February 2, 2021

Re: Comments Regarding ADEM's Proposed Approval of the Construction **Permits Nos. 307-0051-X002 and 307-0051-X001** to Pilgrim's Pride Corporation for the new Gadsden Rendering Plant, Etowah County, Alabama

Figure 1. Proposed WWPTS Facility and Rendering Plant.⁵

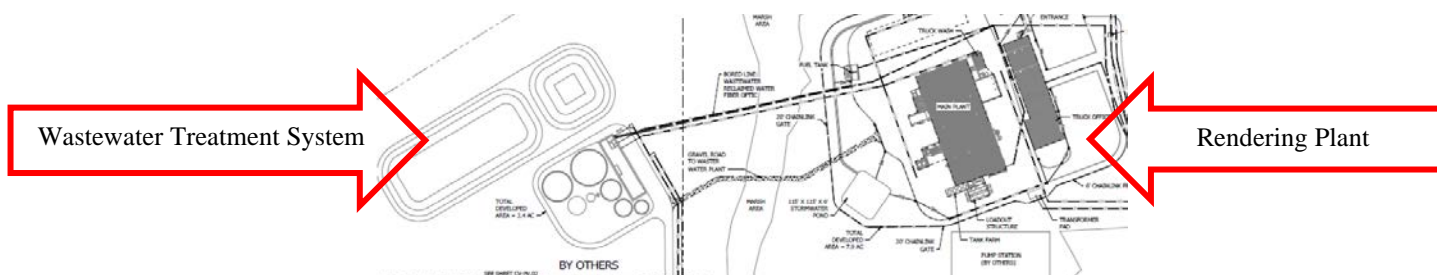
ADEM's response to the "Title V Permit Application," as identified and submitted by Pilgrim's on July 29, 2020, is to propose approval to construct a portion of the proposed new greenfield rendering plant via the two "Air Permits."

Figure 2. Excerpt from the Flow Diagram for the Facility Showing Three Process Concentrate Streams That Would Flow to the WWPTS.

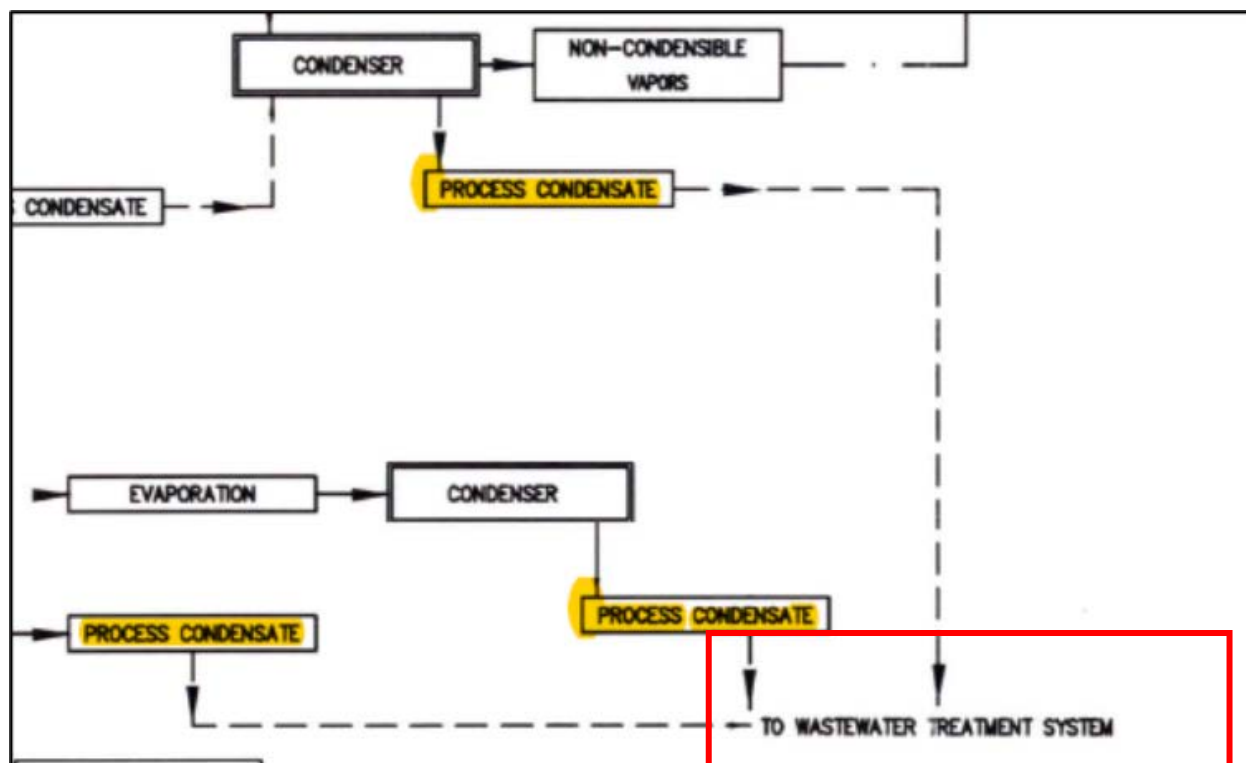
Second, ADEM's proposed action does not include all the buildings, structures, facilities and installations that comprise the source and that emit or may emit a regulated pollutant. Notably absent from ADEM's Engineering Analysis is the WWPTS. The permit application shows that *process concentrate* from at least three different processes would be directly routed to the WWPTS, see Figure 2 below.

speaking in unison and do not contradict one another.⁷³ For example, while the air permit application shows three processes leading to the WWPTS (Figure 2), the water permit shows the 10 listed in Figure 4, as well as sanitary wastewater. Therefore, it seems there is a discrepancy for the ADEM staff to resolve.

Figure 7. Excerpt from Permit Application: Applicant did not Request Synthetic Minor Source Operating Permit.

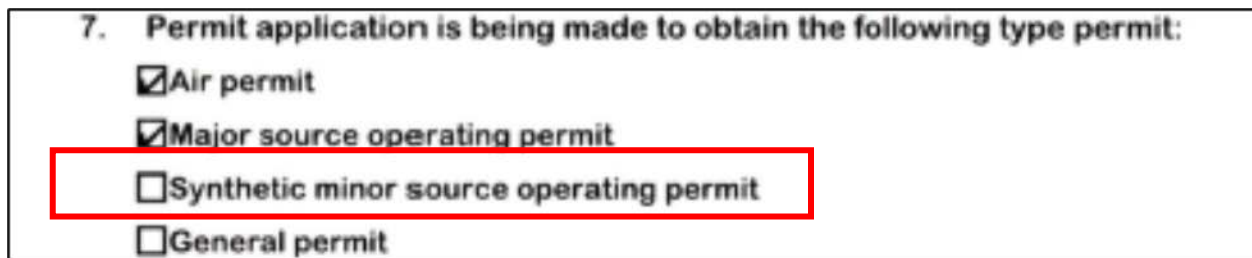
ADEM's permit application forms include an area for the applicant to indicate the type of permit requested. A review of the application submitted by the permit applicant reveals that it did *not* request a "synthetic minor source operating permit," rather as seen in Figure 7, it requested an "air permit."¹⁰⁷

Figure 8. Excerpt from Pilgrim’s Pride Application: Requesting Title V Permit to Operate.

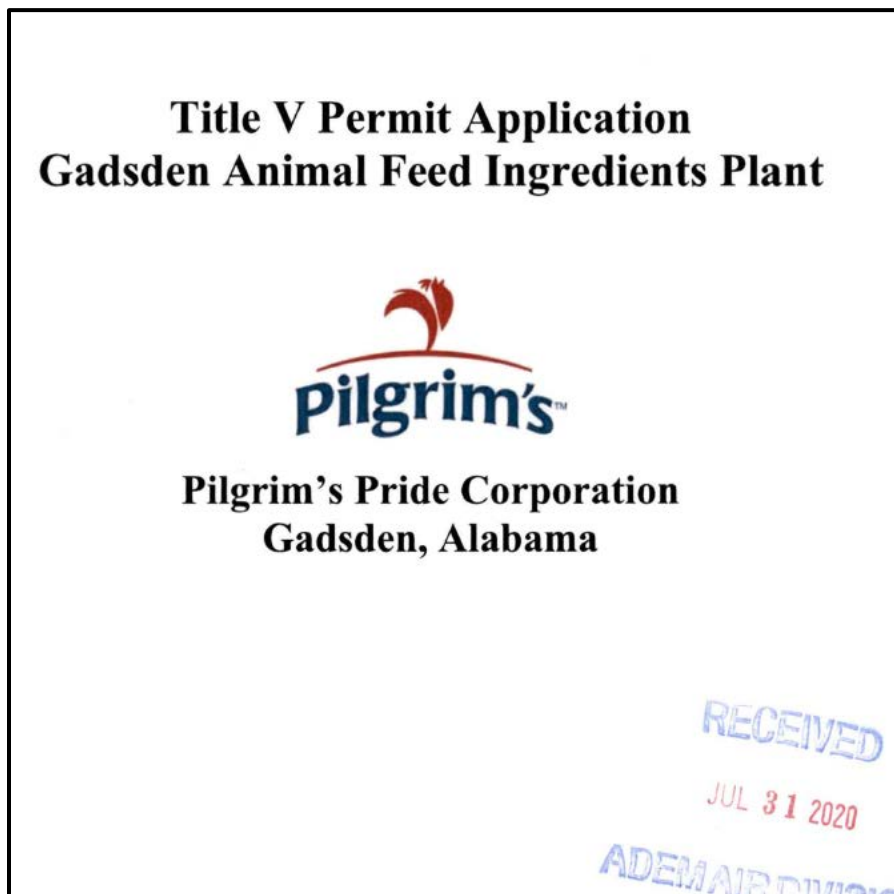
Moreover, Pilgrim's application was titled under the operating permit program – Title V of the Clean Air Act, as seen in Figure 8 below:

Pilgrim’s application used the ADEM’s forms for Title V permits. Title V permits are for sources that received a construction permit(s) and are operating. The Title V permit forms do not contain the information required for a major source that seeks approval to construct using synthetic minor terms and conditions limiting its PTE. This is no doubt why the information that the ADEM considered does not contain the information required by the regulations. Although portions of the Title V form may contain some of the required information, they do not include all information needed. As detailed throughout our comments the application is incomplete. Moreover, as seen in Figure 9, below, ADEM’s website identifies to companies and the public the synthetic minor permit as one type of permit available, citing to the relevant rules. Additionally, ADEM’s website explains that “[t]he Air Division utilizes the same application forms for Air Permits, MSOPs, and SMOPs. Each permit applicant must complete an ADEM Form 103 (Facility Identification Form) for each project. This form must be signed by the appropriate facility representative. Process/equipment specific forms are also required to be submitted in an application.” It is unclear why the ADEM proceeded with proposing to approval this permit without the information required on Form 103.

Title V permit applications are required and submitted *after* construction permits and once a facility has begun operation.¹⁰⁸ This proposed rendering plant is not at that stage yet. Indeed, operating permit applications are due within 12 months *after* commencing construction.¹⁰⁹ Therefore, Pilgrim's Pride submitted the wrong application because it is not yet operating.¹¹⁰ It is no wonder the application does not contain the necessary information for construction, and prematurely includes other information without a basis.^{111, 112} Furthermore, ADEM's website provides the following explanatory information regarding the various permits it issues and its authority for issuing them.
